Memorandum

Subject: Review of Conceptual Approach to Scott Dam Removal and Sediment Management
Geosyntec Project Number: WR2851

Figure 1. Map of Lake Pillsbury showing tributaries. Taken from McBain (2019).

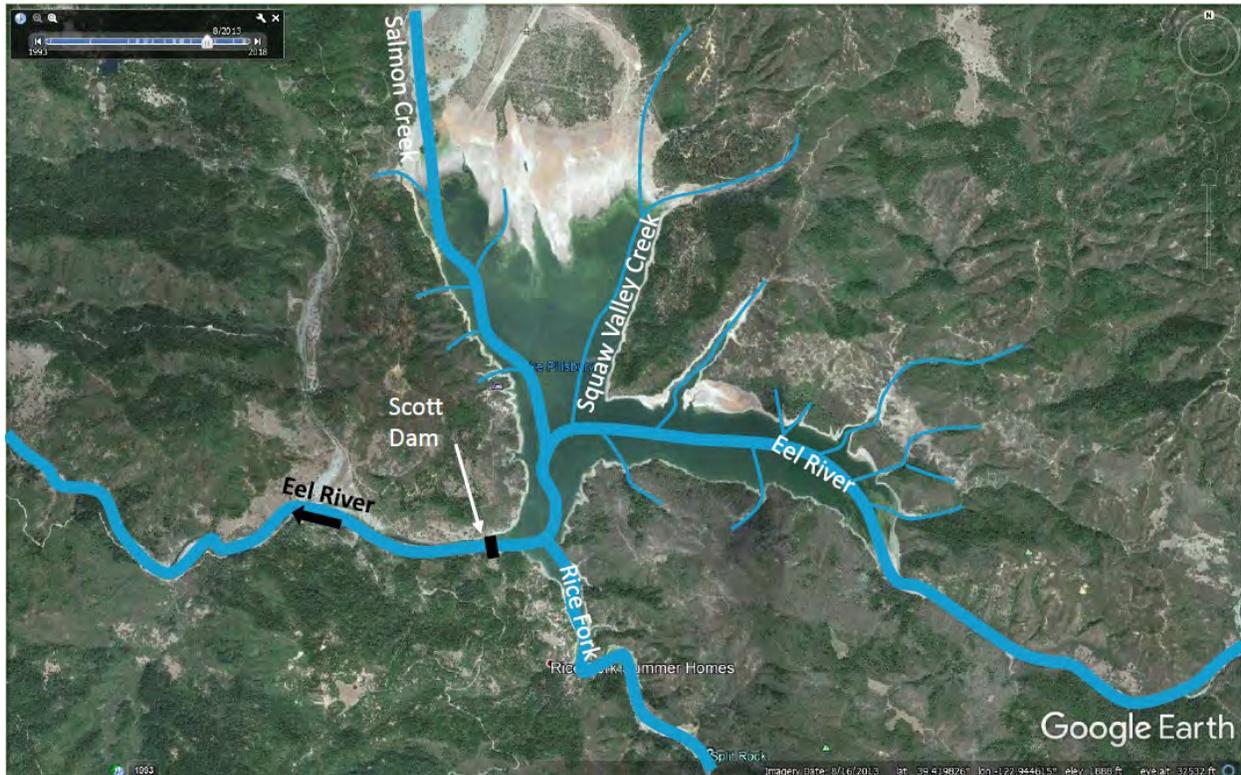
The presentation focuses on the width of the impoundment relative to the width of the channel and the depth of the trapped sediments. Other characteristics that have been shown to be important in determining the fate of trapped sediments following dam removals, including the cohesion of the trapped sediments, and the volume of trapped sediments relative to the sediment transport in a typical year, were not evaluated. The presentation specifically drew lessons from the dam removal as they apply to the mainstem Eel River, Salmon Creek and Rice Fork. Figure 1 shows a map of these tributaries from McBain (2019). Each tributary is discussed separately below.

The Eel River mainstem is a wide impoundment with sediment depths much greater than the bankfull channel depth. The McBain presentation equates this scenario to the Glines Canyon Dam on the Elwha River in Washington State. The presentation notes that a significant percentage of the impounded sediments were mobilized downstream through a process where the channel downcuts into the trapped sediments and creates a wide meander belt through the former impoundment.

The Rice Fork arm has a narrow, confined impoundment approximately equal in width to the channel. The McBain presentation draws lessons for this case from the Condit Dam on the White Salmon River in Washington State. The presentation says that these scenarios often transport 100% of their impounded sediments. Our understating is that approximately 70% of the impounded sediments were mobilized in the first year following the removal of the Condit Dam. Furthermore,

there are cases where a narrow impoundment has had as low as 30% of its impounded sediments mobilized. So, while the Rice Fork does have a key characteristic—a narrow impoundment—that is consistent with rapid erosion of the majority of trapped sediments, it also has cohesive sediments (12.7% clay and 65.8% silt based on Geosyntec Consultants, Inc. [Geosyntec], 2020) and it is uncertain that a staged removal of the dam would yield to rapid full mobilization.

Salmon Creek, part of the North Arm of Lake Pillsbury which also includes Squaw Valley Creek, is a wide impoundment relative to the channel and has shallow sediment depth. The McBain presentation draws lessons for this scenario from the removal of the Tannery Brook Dam in New Hampshire. In the case of Tannery Brook, most of the impounded sediment did not mobilize. This is consistent with the dam removal literature for this type of impoundment.

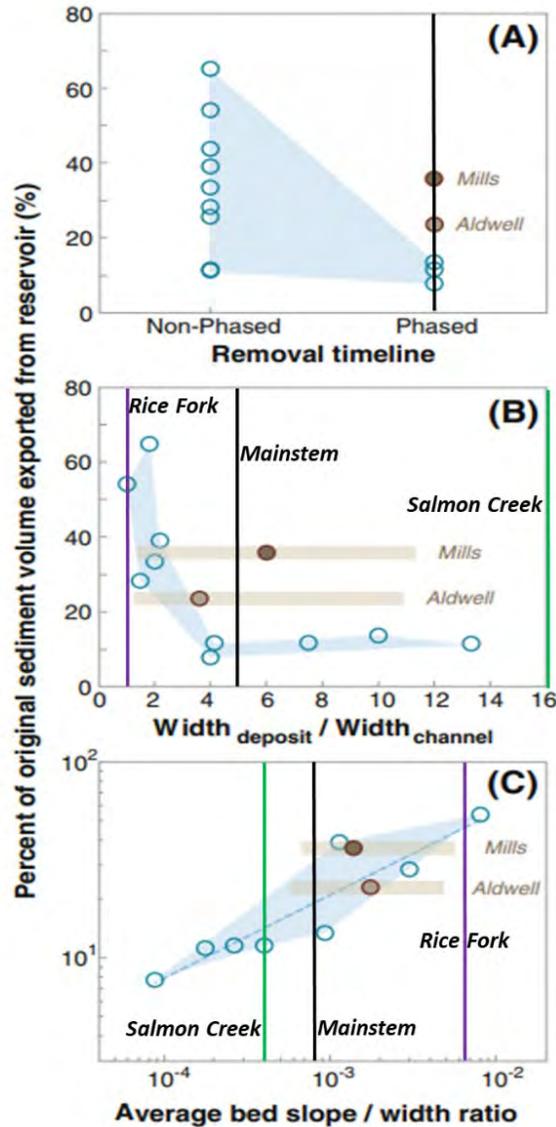
It is instructive to plot Eel River, Rice Fork, and Salmon Creek on several plots obtained from syntheses of dam removal literature. Figure 2 is a figure reproduced from Warrick et al. (2015) with lines indicating Eel River, Rice Fork, and Salmon Creek. The figure indicates that past phased removals have exported 10-40% of the impounded sediment (a). The second panel shows that the ratio of width of the deposit to width of the channel has been important in past removals (b), suggesting that 50-70% of the impounded sediment at the Rice Fork would be expected to be exported, compared with approximately 10% for the mainstem Eel River and approximately 10-20% for Salmon Creek/North Arm. The third panel (c) finds a relationship between the ratio of average bed slope to the width ratio plotted in (b) and the fraction eroded; this relationship would predict approximately 70% erosion efficiency for Rice Fork, 10-40% for the mainstem, and approximately 10% for Salmon Creek/North Arm. This compares with the estimated 55-59% estimated removal based on McBain (2020) and is consistent with the McBain work being an upper bound estimate on the post-removal erosion.

Figure 3. Modified from Major et al. (2017). Scatterplot of V^* and E^* (defined above) as a function of sediment volume stored in the reservoir.

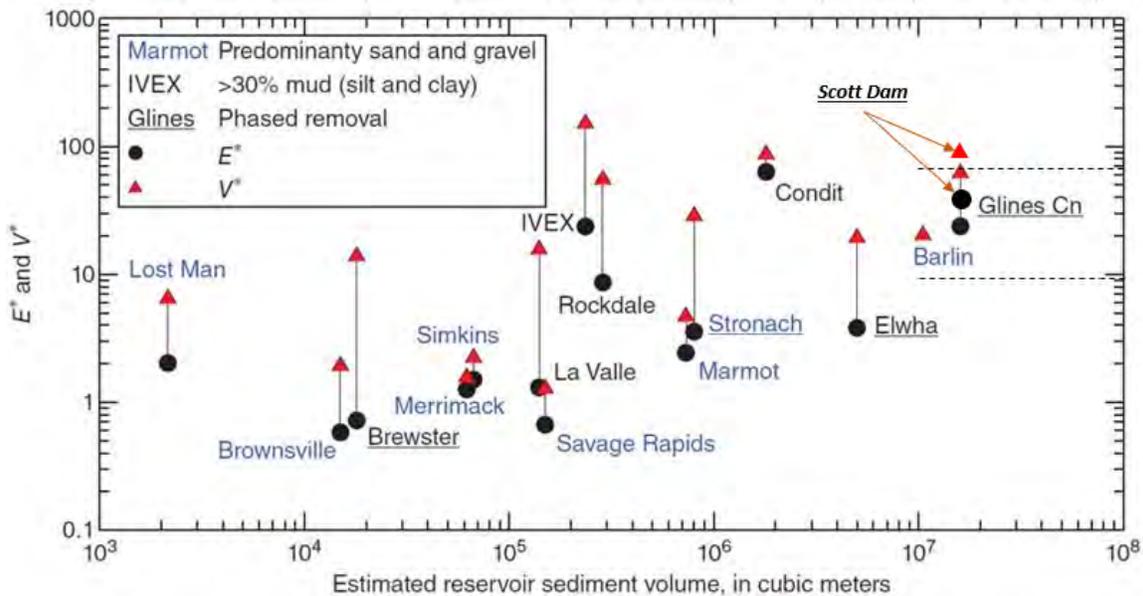
Figure 3 shows another scatterplot comparing past dam removals, modified from Major et al. (2017). The x-axis represents the amount of sediment trapped behind the dam and the y-axis represents two different dimensionless ratios:

- V^* is the ratio of reservoir sediment volume to estimated volume of sediment transported in a year (annual sediment load). For Scott Dam, the annual sediment load was estimated by taking the approximate annual sediment deposited per year, estimated to be 226,000 cy (the average of the two estimates calculated using the McBain volume estimates) and adjusting by assuming a 94% trap efficiency. A 94% trap efficiency is a reasonable estimate based on Porterfield and Dunnam (1964) but possibly too high since the amount of fine sediment passing by the dam is unknown. Using these two assumptions, the estimated annual sediment load is 240,000 cy per year. Dividing the average of the reservoir sediment volume estimates (21.2 million cy) by the estimated annual sediment load results in an estimated V^* value of 88 for Scott Dam.

- E^* is equal to V^* multiplied by the fraction of reservoir sediment that is eroded during the first year following dam removal. Dotted lines are shown representing removal fractions of 10% and 60% and a black dot representing Scott Dam is shown at the average value of 35%: $E^* = V^* \times 0.35 = 88 \times 0.35 = 31$.

Important observations from Figure 3 relevant to Scott Dam and Lake Pillsbury include:

- The higher estimate of sediment volume trapped behind Scott Dam (22 million cy or 16.8 million cubic meters) is higher than the estimated sediment volume for any dam removal in the Major et al. dataset, slightly higher than for the Glines Canyon Dam.

- For some past dam removals, e.g., the Condit Dam, E^* and V^* are relatively similar, meaning that a substantial percentage of the stored sediment is mobilized in the first year. However, for the two phased removals of dams with >30% silt and clay in the impoundment, E^* is just 7% (Brewster) and 33% (Glines Canyon) of V^* , meaning that much of the trapped sediment is not mobilized, at least in the first year.

- The two dashed black lines representing 10% and 60% removal of impounded sediment in the first year represent a range of 2.05 to 13.2 million cy of sediment transport in the first year when also considering the range of trapped sediment estimates from McBain.

- While there is substantial uncertainty regarding the fraction of the sediments that will be mobilized following dam removal, the high V^* value means that there is a large amount of sediment stored behind the dam relative to the annual sediment load. This means that there is substantial potential for downstream impacts in the short-term and medium-term (e.g., turbidity increases, aggradation of the channel, etc.) Sediment transport modeling will be critical to understand the extent and implications of these downstream effects and the ability of a phased removal approach to mitigate these impacts.
